## ADDENDUM #01

### ADA Work – Oceanside High School

Oceanside Unified School District	Program Management: CCM/MAAS
Bid No. 2024-21-092B ADA Work – Oceanside High School	Program Manager: Penny McGrew

Informational Updates
1. Change to Bid Due Date/Time
2. Site Walk Sign-In Sheet
3. Pre-Bid RFI Responses
4. Product Data & Details

**5 ENLARGED PARKING**  
1/8" = 1'-0"

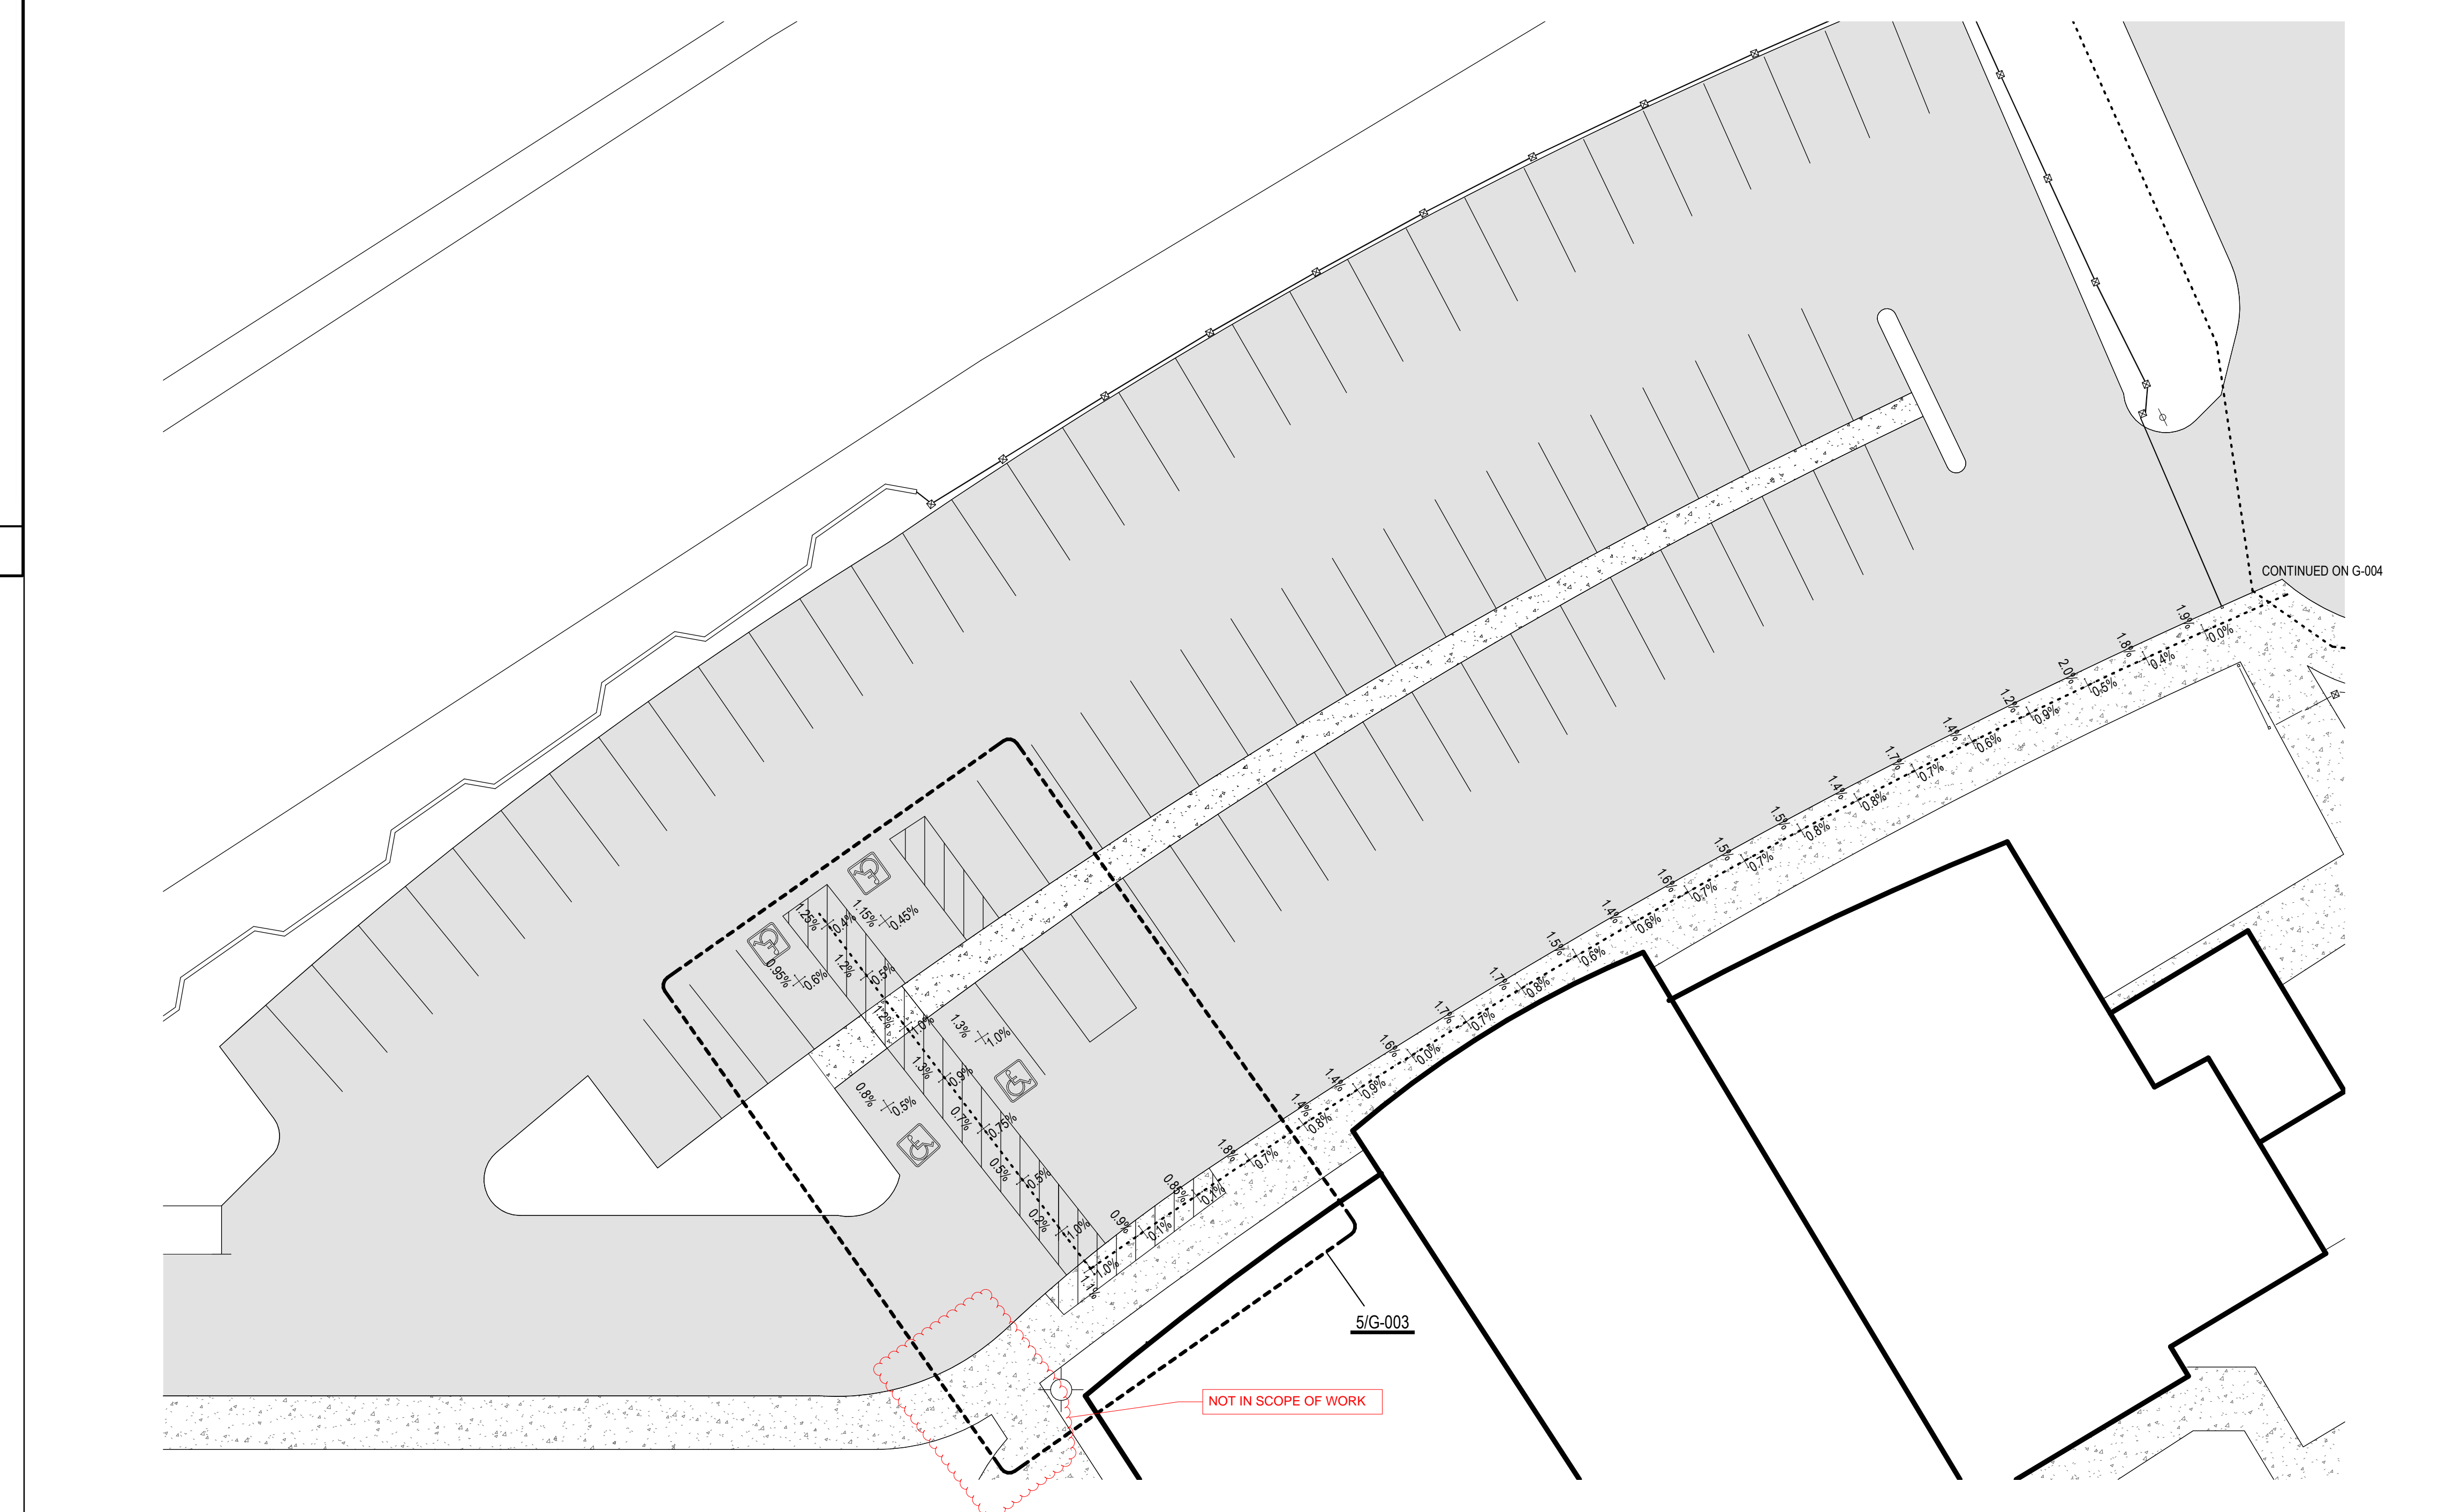
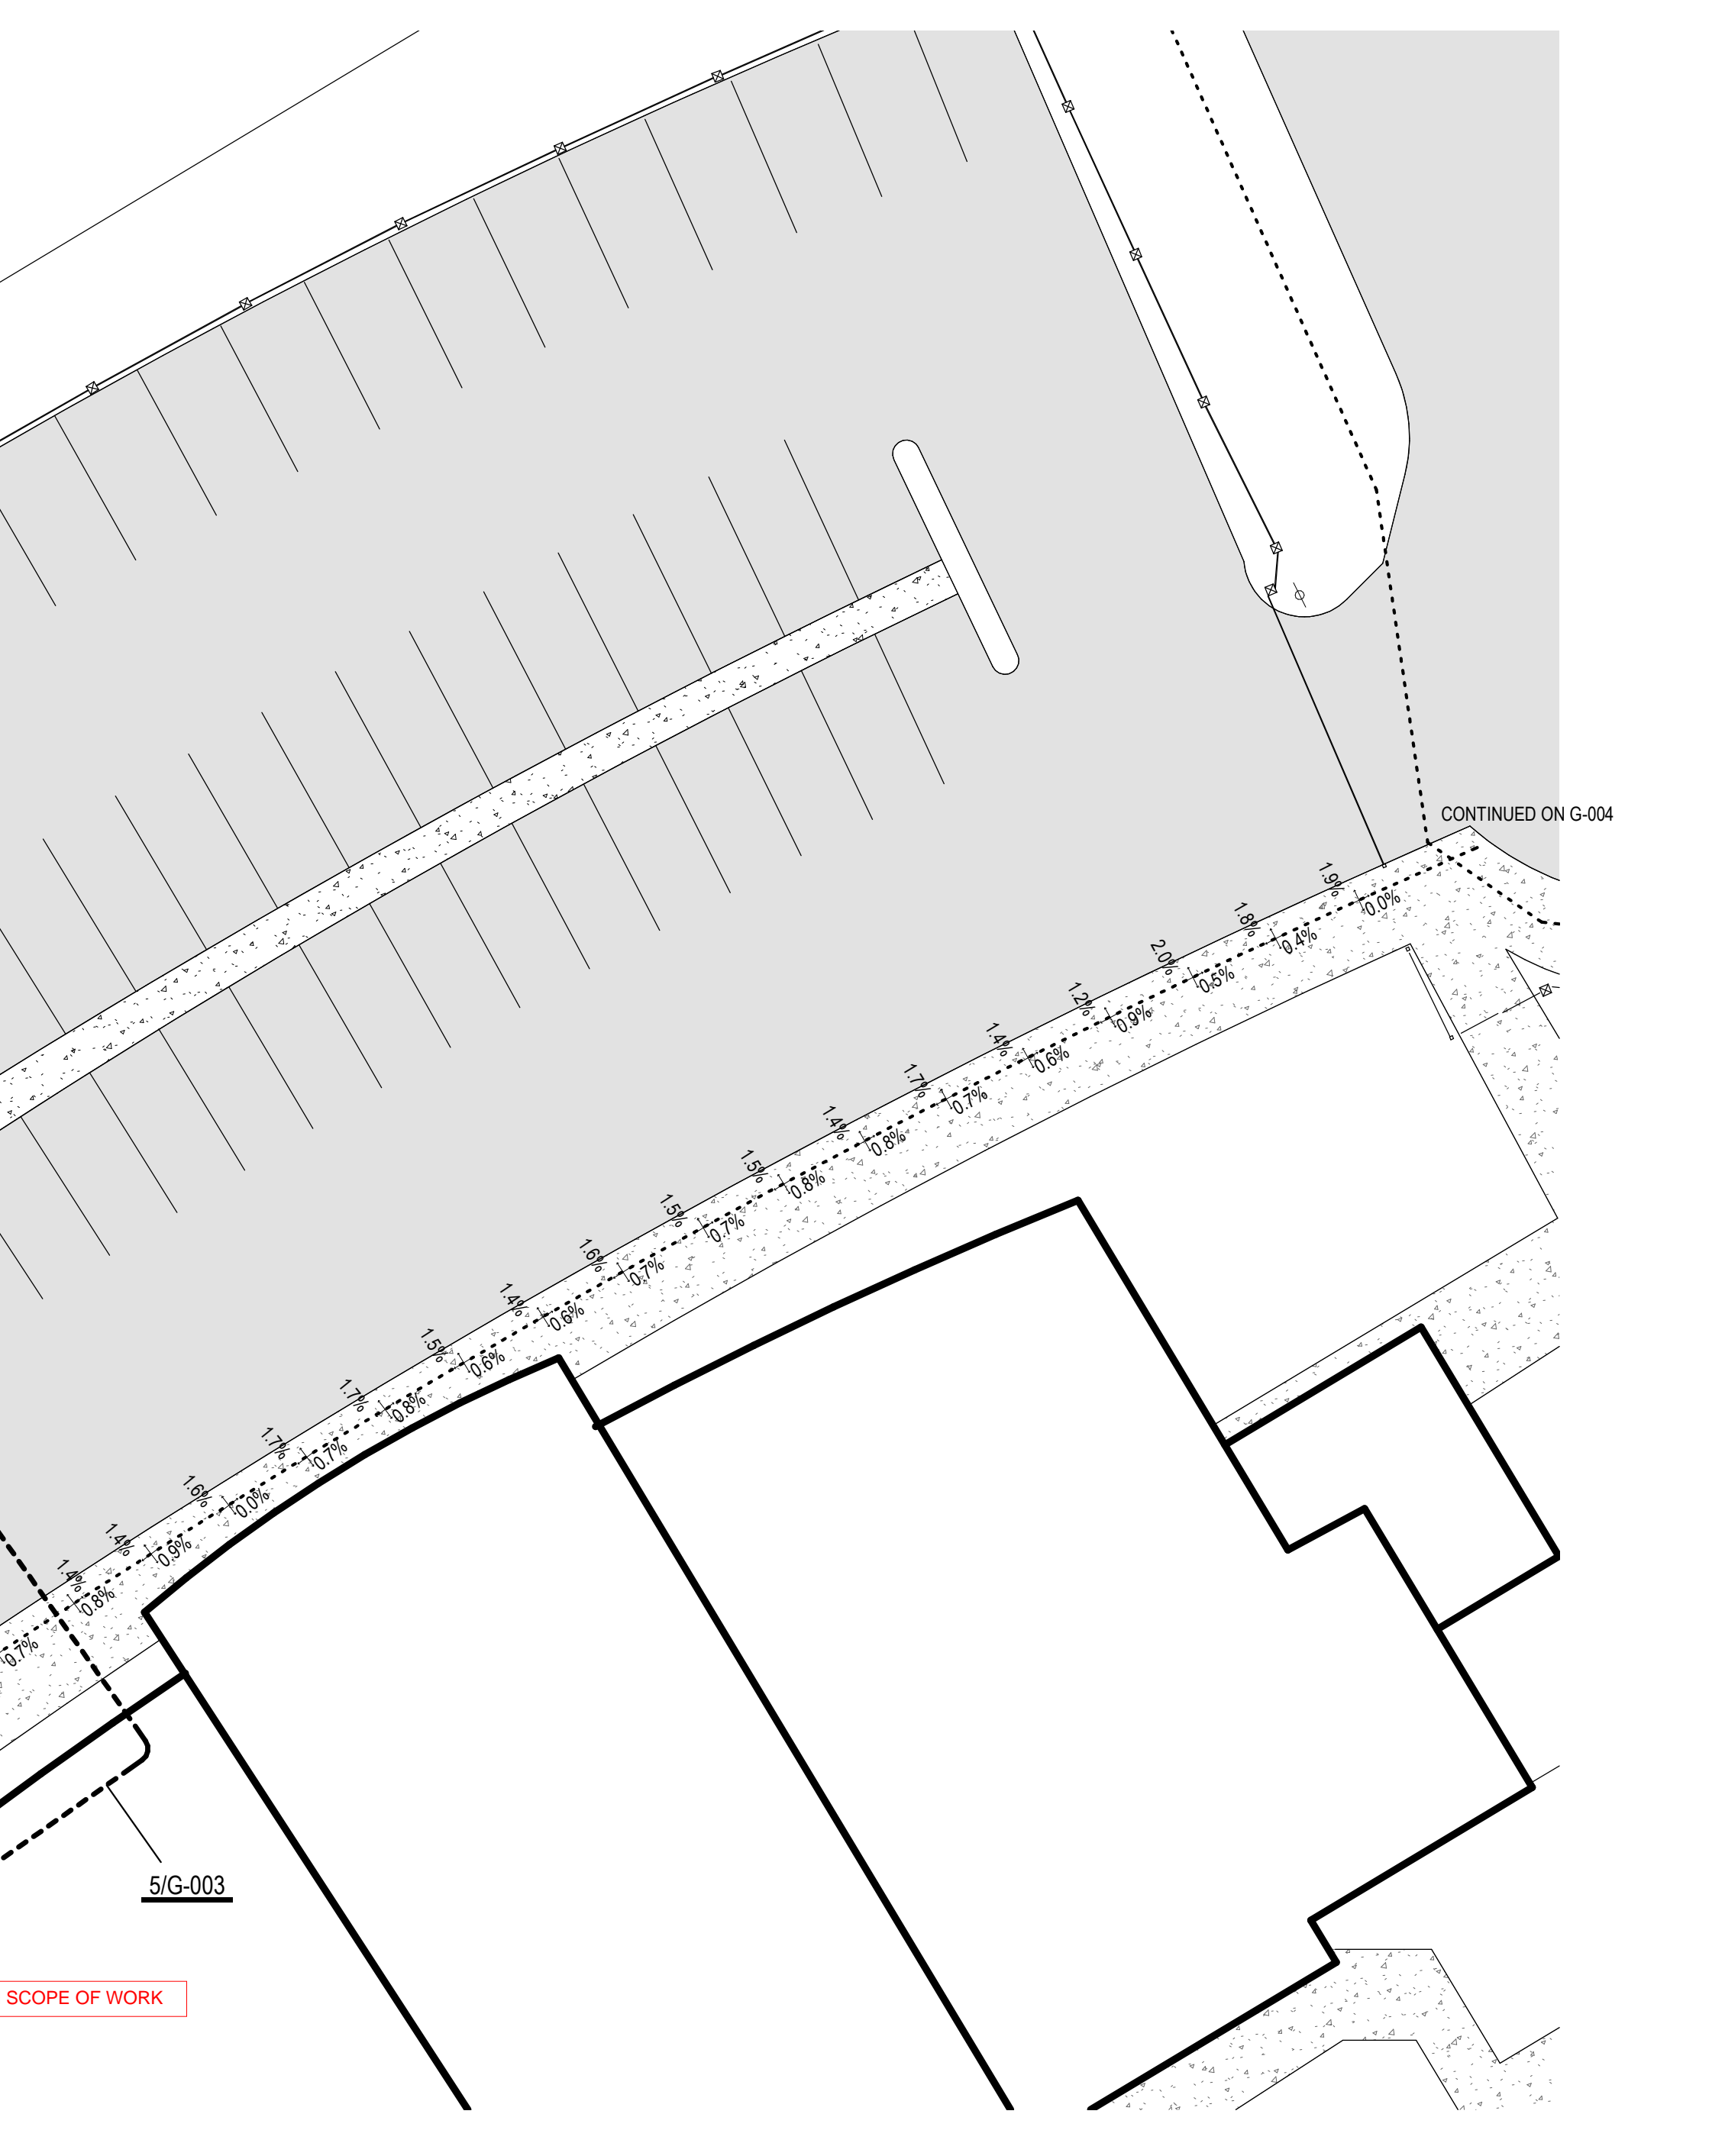
<p>7.</p>	<p>During the Contractor Site Walk, contractors were concerned that the existing concrete located near the path of travel exceeded the ADA max slope allowance at both Accessibility Site Plan - Parking Lot A G-003/Detail 5 and Accessibility Site Plan - Parking Lot B/ North G-004 Detail 1. Please provide clarification to bidders.</p>	<p>Existing concrete did not exceed max slope along path of travel. Confirmed on site walk with 4'-0" level. See attached images and locations on plan.</p>
